HISTORIC AND DESIGN REVIEW COMMISSION

May 01, 2020

HDRC CASE NO: 2020-048
ADDRESS: 363 BRAHAN BLVD
LEGAL DESCRIPTION: NCB 3855 (NARCISSA PLACE {AMENDING}), BLOCK 1 LOT 33
ZONING: R-6,H
CITY COUNCIL DIST.: 2
DISTRICT: Westfort Historic District
APPLICANT: ROSS BENLINE/BELLAIRE-HAGEN, LTD.
OWNER: JOHN BROWN/BROWN JOHN TYRE
TYPE OF WORK: New construction of a 1-story, single-family residential structure
APPLICATION RECEIVED: March 04, 2020
60-DAY REVIEW: May 4, 2020
CASE MANAGER: Rachel Rettaliata

The applicant is requesting final approval to construct a 1-story, single-family residence with a detached two-car garage at 363 Brahan.

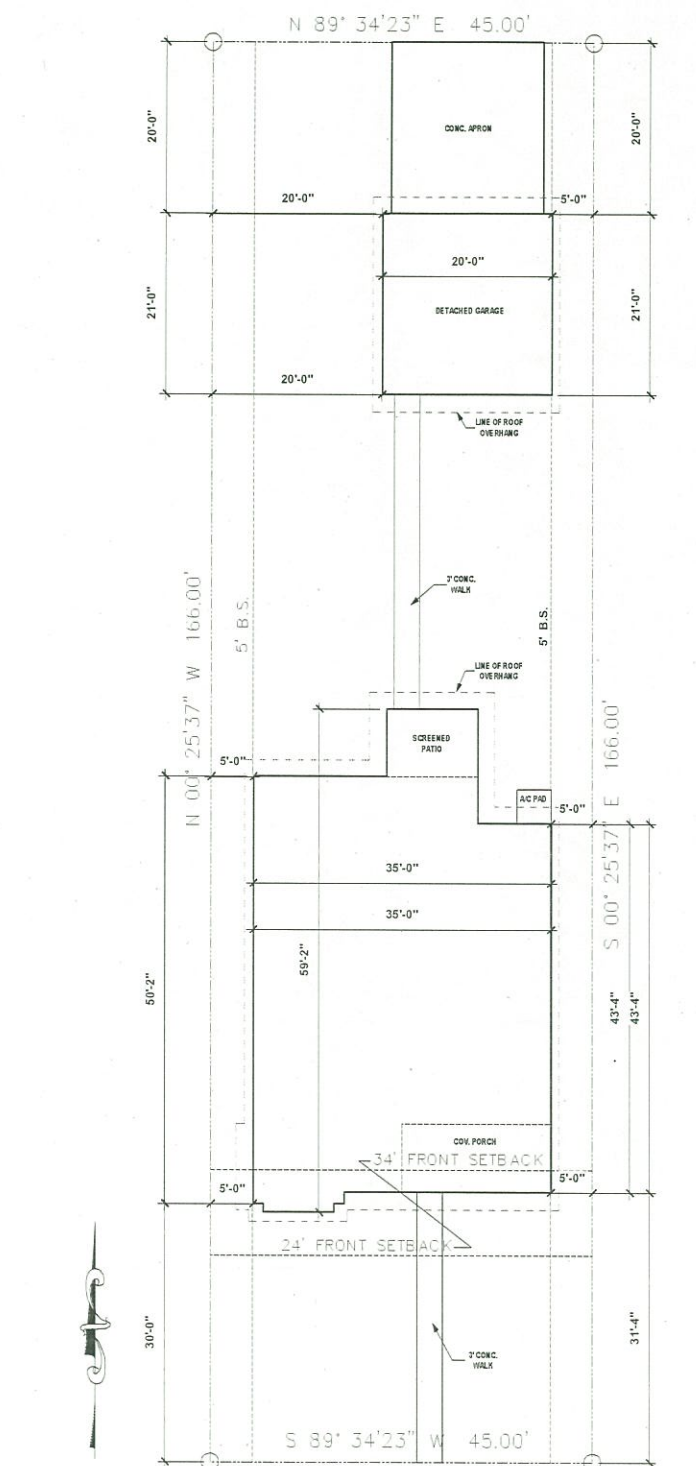
RB- WE CAN MAKE A 5FOOT WINDOW TO MATCH THE ARCHWAYS.

AMG- LET'S DISCUSS THE OTHER SIDE PENETRATION.

EXPLORE LARGER WINDOWS IN THE KITCHEN TO SHOW SYMMETRY ON THE FACADE

ADD ANOTHER WINDOW IN BEDROOM IN PLACE OF TWO HIGH WINDOWS IN KITCHEN.
